## DIXON MEADOWS JSP14-46 with Rezoning 18.709

Public hearing at the request of Pulte Homes for Planning Commission's recommendation to City Council for rezoning of property in Section 10, on the east side of Dixon Road, north of Twelve Mile Road from RA (Residential Acreage) to RM-1 (Low Density, Low-Rise Multiple-Family Residential) with a Planned Rezoning Overlay. The subject property is approximately 22.36 acres and the applicant is proposing a 95 unit single-family residential detached site condominium development.

## PLANNING REVIEW

Review based on Revised Concept Site Plan on June 18, 2015

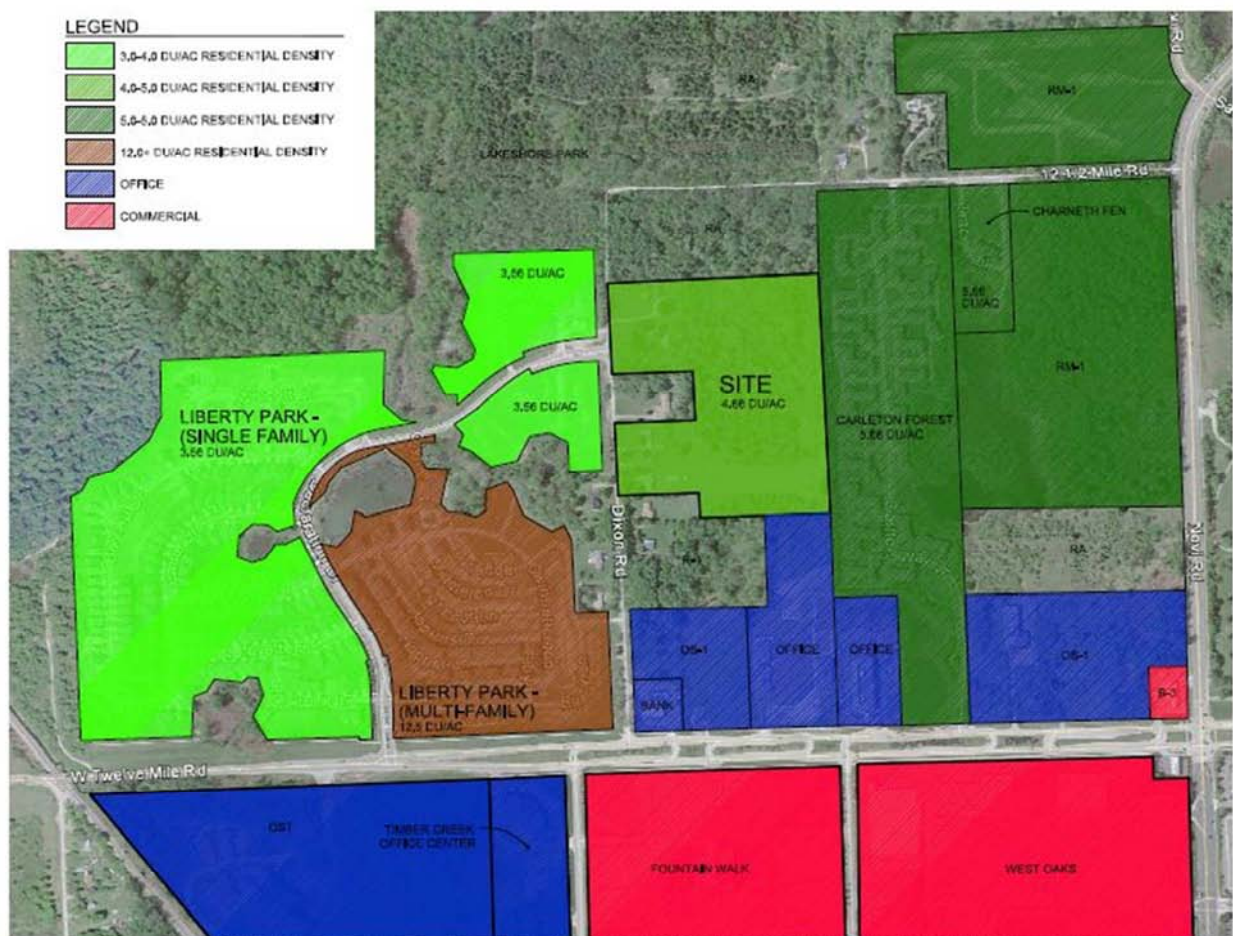
***Ordinance Deviations:** The applicant should consider submitting supplemental material discussing how if each deviation “were not granted, it would prohibit an enhancement of the development that would be in the public interest, and that approving the deviation would be consistent with the Master Plan and compatible with the surrounding areas.”*

**Response:** A response to this request was provided in our resubmittal letter dated June 15, 2015. The specific response was as follows: Pulte Homes is currently under construction in the nearby Berkshire Pointe development. That housing product and development has been very well received in market, with a lot size and price point that varies from a majority of the single family product within the City,
